Birchall Garden Suburb
 Responses to questions raised by Tim Croot – EHO, Welwyn Hatfield Borough Council
 8 August 2017

This response is intended for the sole purpose of addressing the questions below and is not proposed as a formal planning document. All the information proposed below shall be set out within the relevant sections of the planning application in due course.

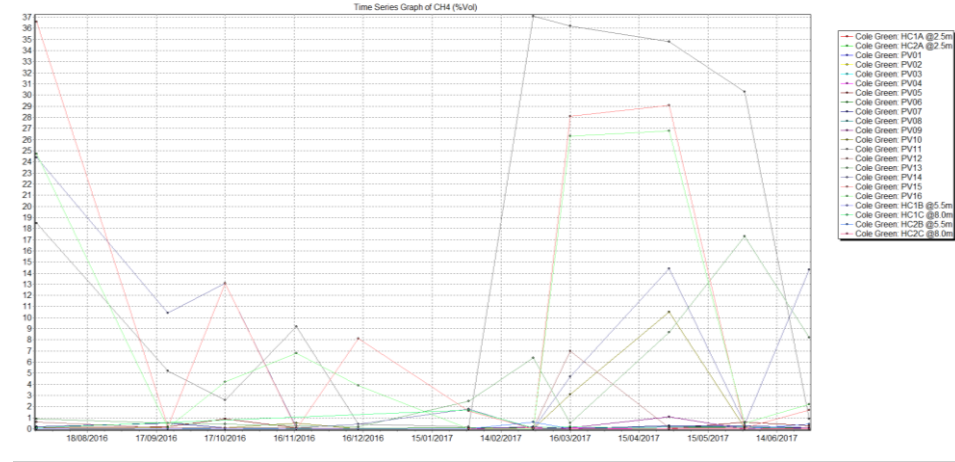
Question 4	Has further monitoring been undertaken at the two surface waters with respect to PCOC?
Response	Tarmac has voluntarily monitored and managed the landfill for over 30 years. Surface water is monitored at various locations in the River Lea, River Mimram and the associated tributaries, for various PCOC. Nine locations are monitored monthly and a further 28 locations on a quarterly basis. In addition, RHDV has independently undertaken two additional rounds of monitoring since the 2014 report.

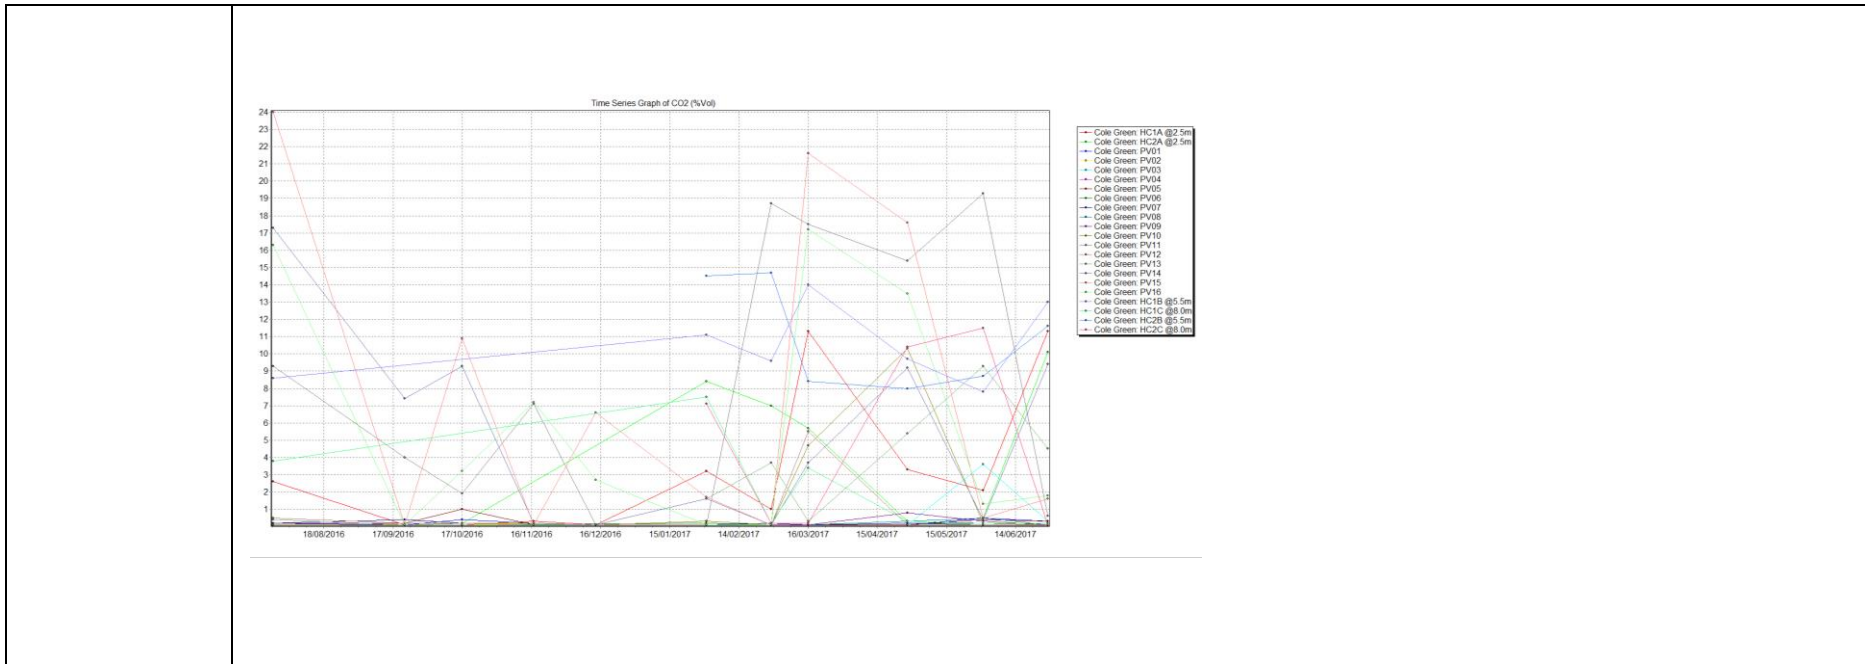
Question 5	How have you concluded that any exposure to PCOC at surface waters is likely to be minimal?
Response	Further Risk Assessment has been undertaken with regard to impact on surface waters including the preparation of an outline mitigation strategy where the exposure risk has been revised to account for the change in land use.
